R0189

Subject: Fuel Leak Case No. RO0000189 and Geotracker Global ID T0600101353, Chevron #21-1253/Texaco, 930 Springtown Boulevard, Livermore, CA 94550 – Work Plan Comments

Alameda County Environmental Health (ACEH) staff has reviewed the fuel leak case file for the above-referenced site, including the recently submitted document entitled, "Site Investigation Work Plan," dated April 18, 2007. The Work Plan proposes soil and groundwater sampling from cone penetration test (CPT) soil borings. We request that CPT soil borings be advanced at six locations and that the sampling methods be revised as discussed in the technical comments below. The proposed scope of work may be implemented provided that the technical comments below are addressed and incorporated during the proposed field investigation. Submittal of a revised Work Plan is not required unless an alternate scope of work outside that described in the Work Plan and technical comments below is proposed.

Revised Figure 2

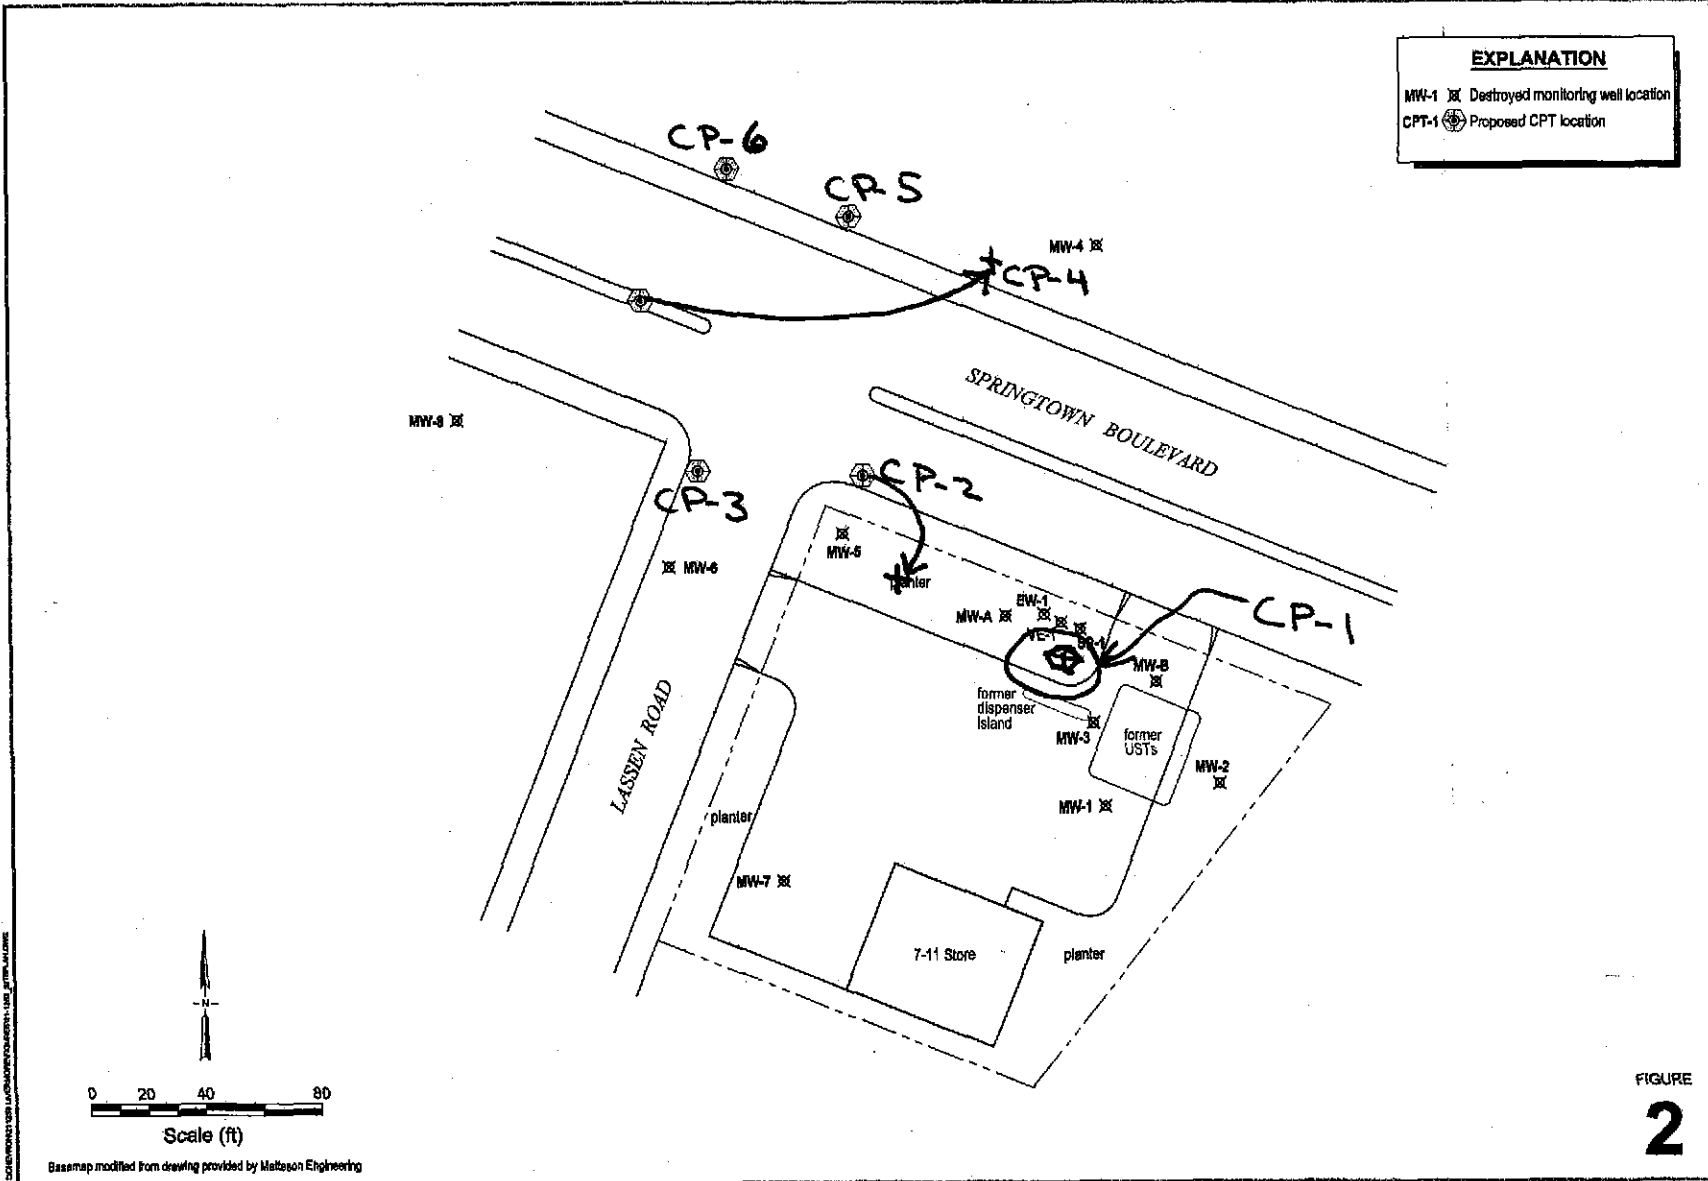
1. **Proposed Soil Boring Locations.** The Work Plan contains a discrepancy in the number of CPT soil borings proposed. The text in the first paragraph of the Proposed Scope of Work on page 3 and Figure 2 proposes five CPT borings; however, the text at the bottom of page 3 proposes six CPT borings (CPT-1 to CPT-6). In order to meet the objectives of defining plume extent laterally and vertically, we request that six CPT borings be advanced at the locations shown on the attached Revised Figure 2. Please present the results in the Subsurface Investigation Report requested below.
2. **Proposed Soil Sampling.** The Work Plan currently proposes the collection of soil samples every five feet starting from five feet bgs to total depth of the CPT borings. We concur with the proposed soil sampling at five-foot intervals for the two CPT borings requested on-site

(CP-1 and CP-2 on Revised Figure 2). For the four downgradient borings (CP-3 through CP-6) that are outside the potential source area, we are not requiring the collection of soil samples at five foot intervals for chemical analyses. We request that one soil sample be collected from the zone of water table fluctuation in borings CP-3 through CP-6. Please present the results in the Subsurface Investigation Report requested below.
